**RE: BREWERY, DISTILLERY, SAMPLING ROOM, DRIVE-THROUGH BOTTLE SHOP  
POST OFFICE BREWING CO.  
55 LAKESIDE DRIVE  
RESPONSE TO INFORMATION REQUEST**

**RE: BREWERY, DISTILLERY, SAMPLING ROOM, DRIVE-THROUGH BOTTLE SHOP  
LLKB INVESTMENTS PTY LTD  
55 LAKESIDE DRIVE  
APPLICATION No.: MCU24/0083  
ASSESSMENT No.: 3230055  
LOT 14 SP 334259  
RESPONSE TO INFORMATION REQUEST**

## **INFORMATION REQUEST**

DRAWING NAME  
**PROPOSED FULL SITE PLAN - STAGES 1 - 3 INCL**

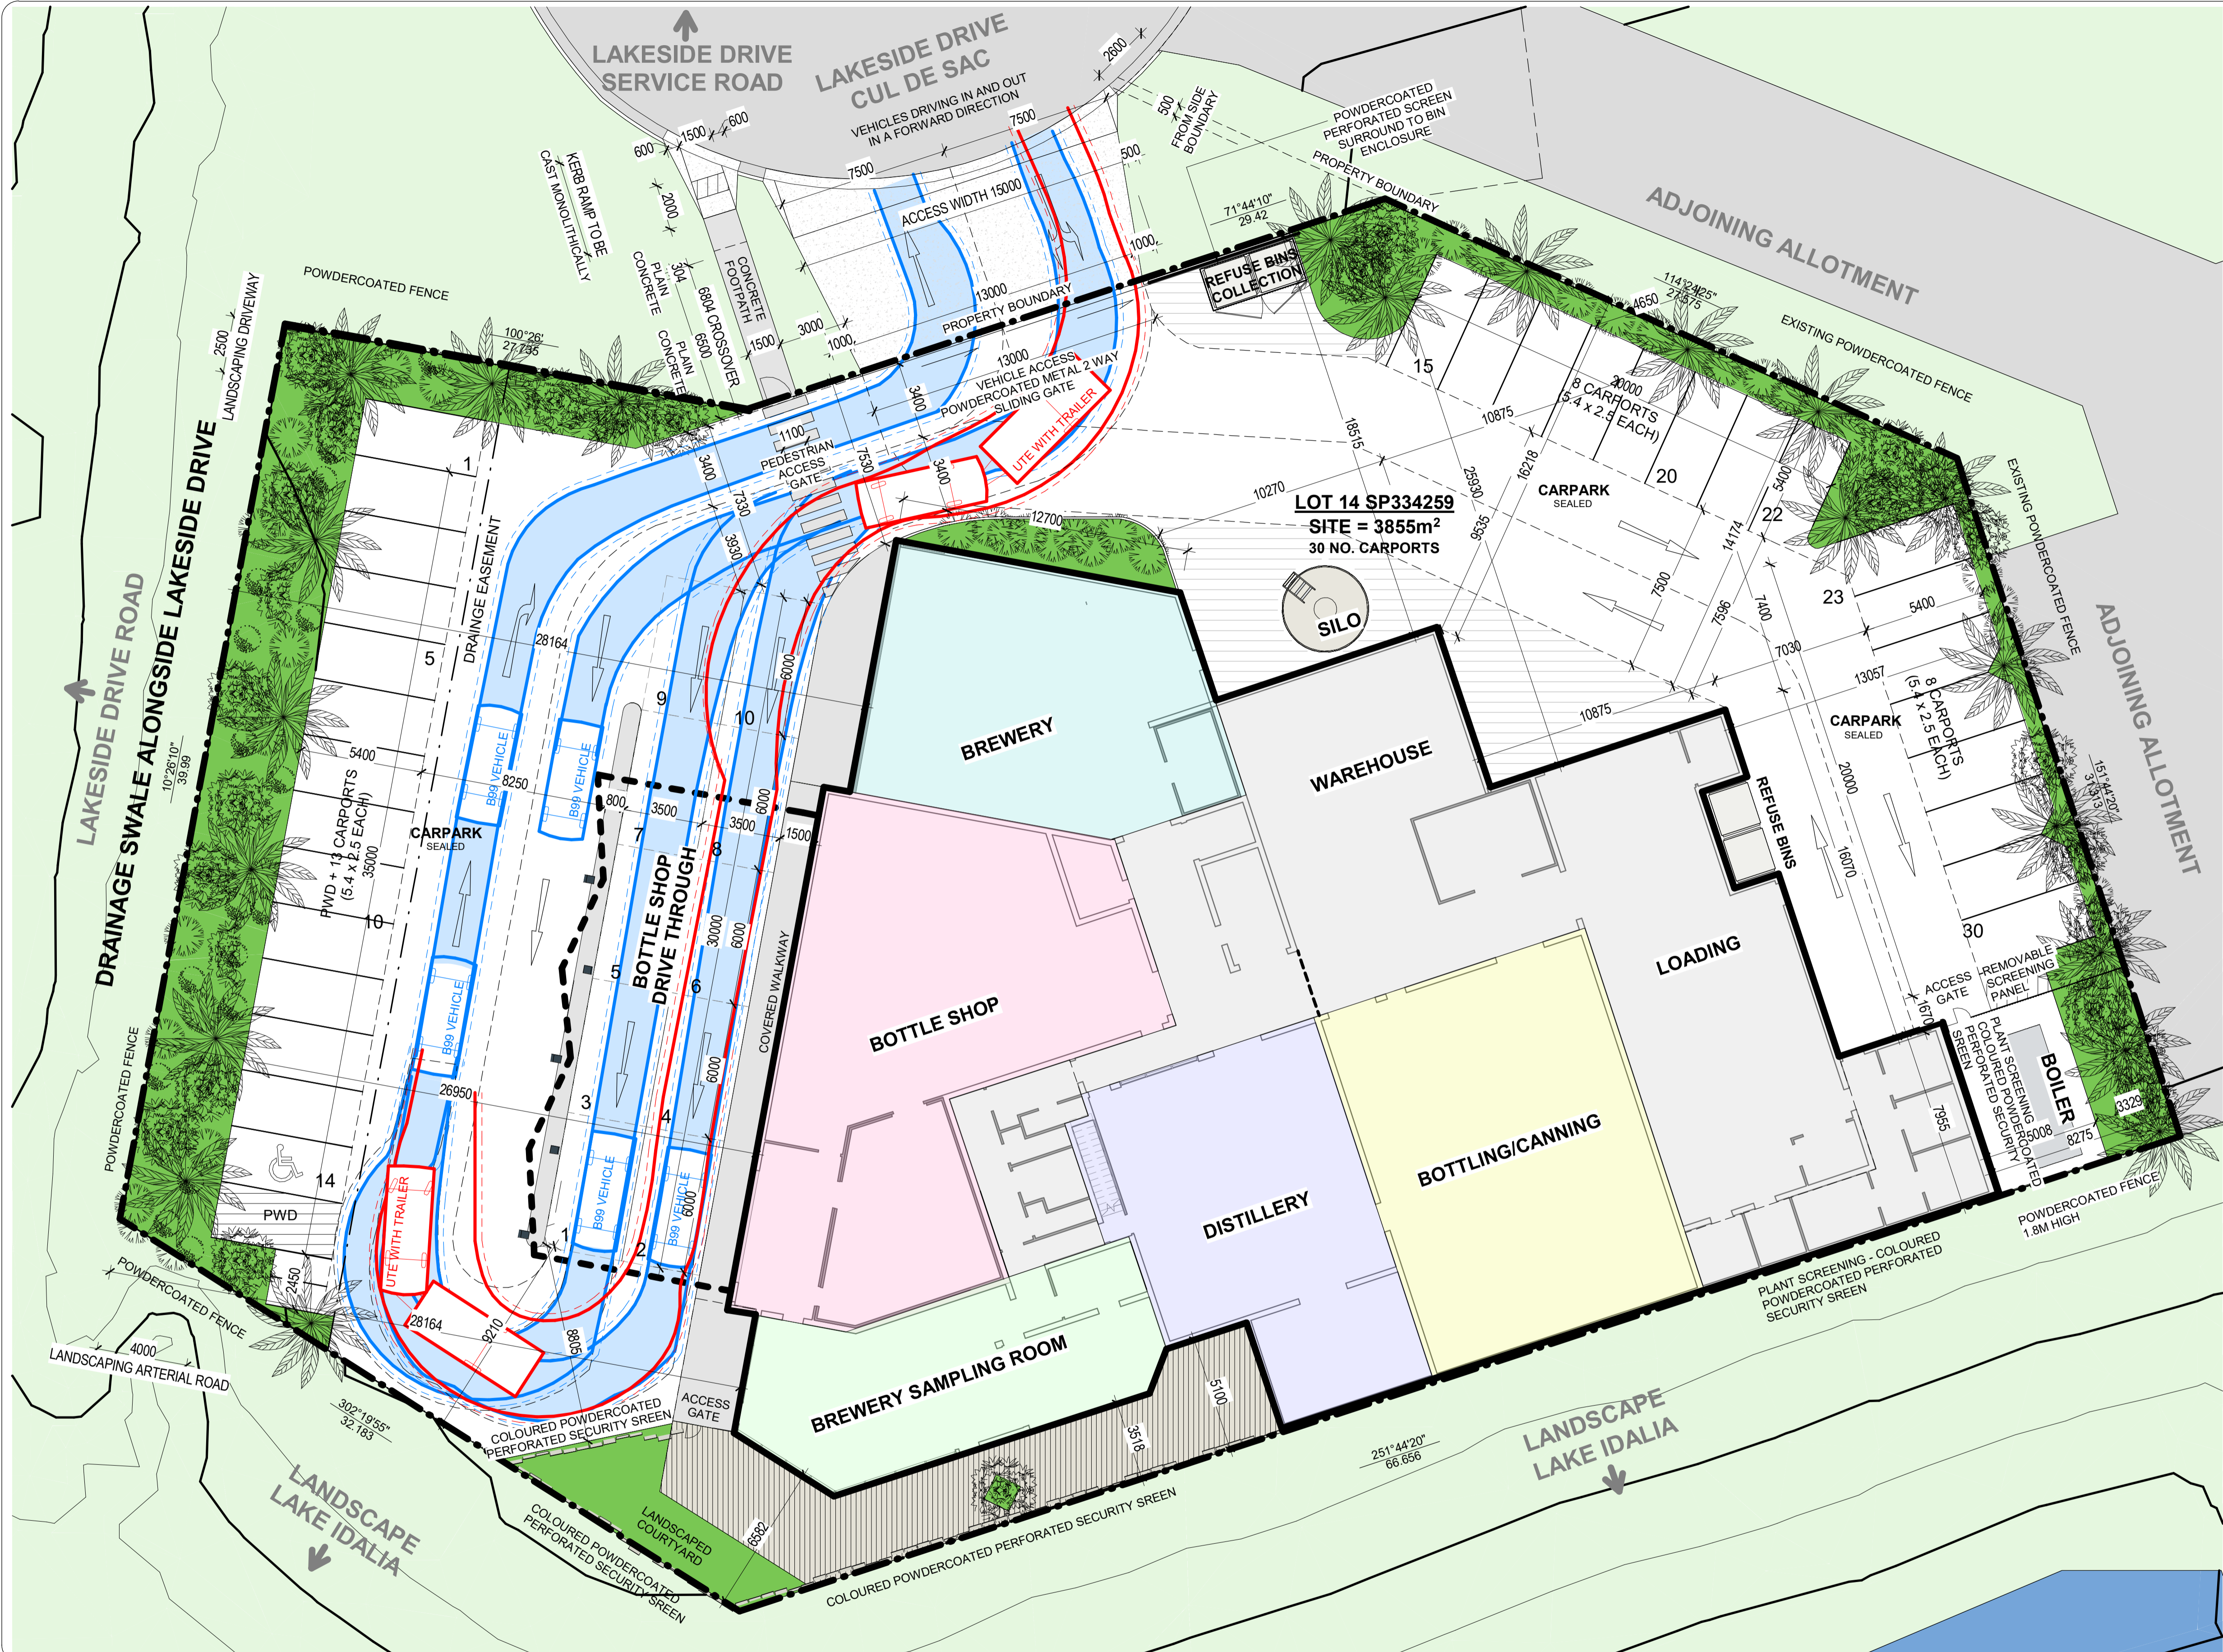
#### **Request Item 5 - Driveway Crossover**

The applicant is requested to redesign/relocate the proposed crossover so as to comply with the design requirements of the current version of Standard Drawing SD-031 (Driveway Access Industrial), in particular achieving typical crossover dimensions and adequate separation from property boundaries.

Widening the crossover at the kerb and shifting the crossover further west will provide less conflict with the adjoining property, and allow for improved ingress, egress and on-site vehicle manoeuvrability.

<p><b>Request Item 5</b> Driveway Crossover</p>	<p>This item requested to redesign / relocate the proposed crossover to achieve typical crossover dimensions including adequate separation from adjacent property boundaries.</p> <p>In response to this item, we refer to the amended Dillon Architects' drawings (see attached <b>Attachment 2 – Concept Design Plans – Rev B</b>). The crossover has been widened at the kerb and relocated further to the west to provide increased separation from the adjoining property.</p>
<p><b>Request Item 6</b> Pedestrian Connectivity</p>	<p>This item requested to provide a pedestrian footpath and / or corridor between the Lakeside Drive cul-de-sac and the covered walkway proposed along the western side of the building, which is separate from vehicle movement areas.</p> <p>In response to the item, we refer to the amended Architectural drawings (see attached <b>Attachment 2 – Concept Design Plans – Rev B</b>). The pedestrian concrete footpath between the Lakeside drive cul-de-sac and the site boundary and a pedestrian corridor between the site boundary and covered walkway to the Proposed Brewery have been added. A pedestrian access gate to the site has also been added. The concrete footpath is 1.5m wide and is separated 3m from the driveway crossover. The connection between the concrete footpath and the Lakeside Drive cul-de-sac has been modified with a kerb ramp, in accordance with Standard Drawings SD-025 (Kerb Ramp).</p>

DRAWING NAME  
**PROPOSED FULL SITE PLAN - VEHICLE TURNING CIRCLE, CAR WITH TRAILER / CARAVAN**

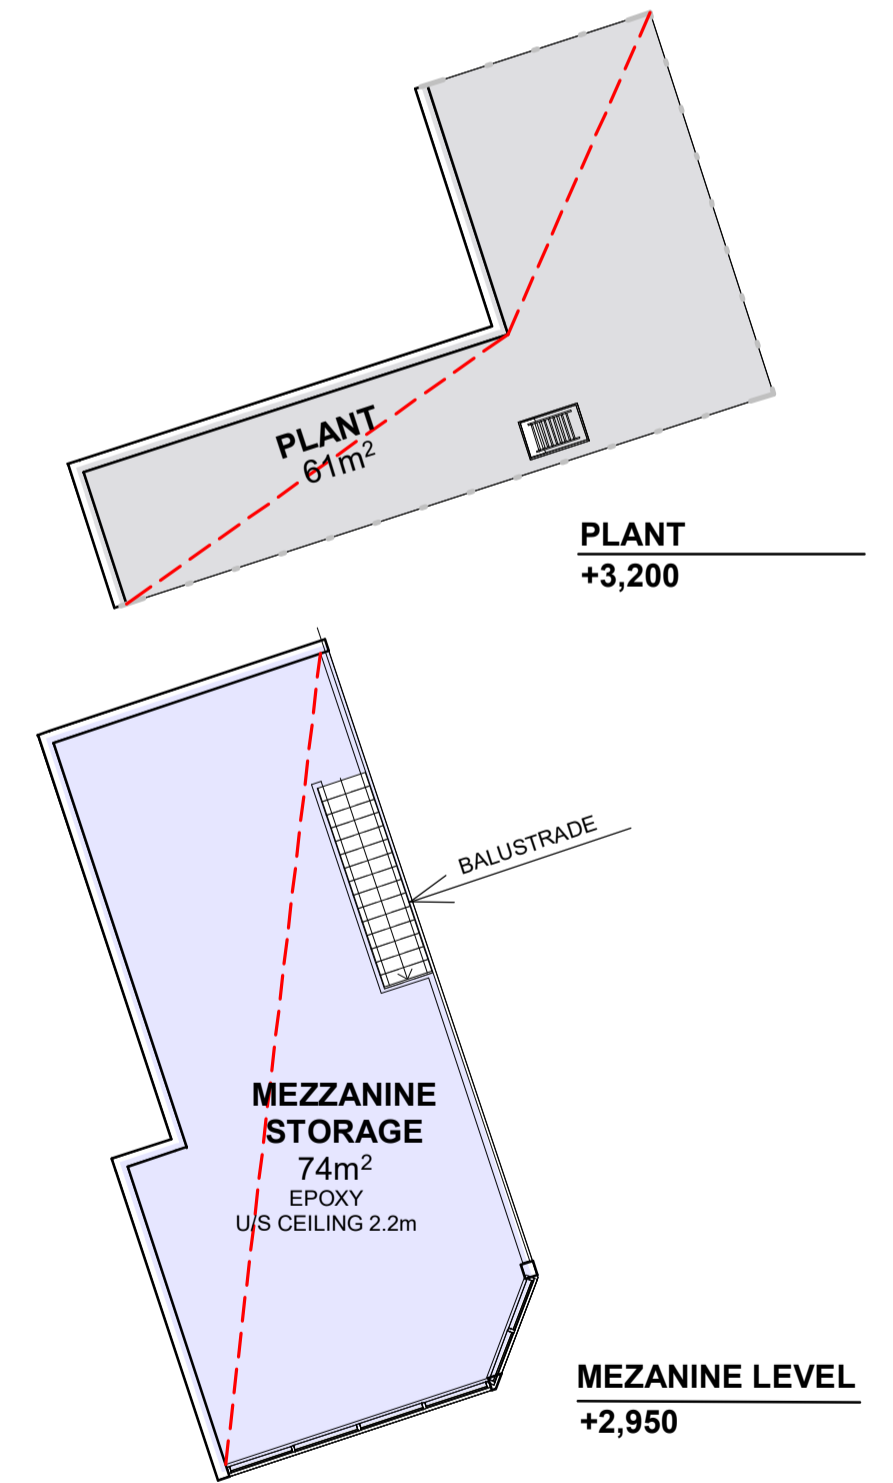
#### Request Item 8 - Drive Through Manoeuvring

The applicant is requested to supply additional information confirming that the anticipated customer vehicles can generally exit the drive through facility with a single turning manoeuvre.

The supplied swept paths contain insufficient detail regarding assumed design vehicles and turning radii, noting that uses with trailers/cars with caravans are likely to frequent the proposed drive through facility.

In response to this item, we refer to the amended Architectural drawings (see attached **Attachment 2 – Concept Design Plans – Rev B**). The driveway providing access to the drive-through facility for entering and exiting has been widened. Information about the assumed design vehicles, along with the associated swept paths, have also been added.

LCJ Engineers have confirmed that utes with trailers or cars with caravans are not design vehicles in AS/NZS 2890 Parking facilities and are not mentioned within TCC City Plan. LCJ Engineers have provided a swept path template from another region to confirm that utes with trailers / caravans can enter and exit the drive-through facility with a single turning manoeuvre using the left lane. This is showed on the amended architectural drawings.
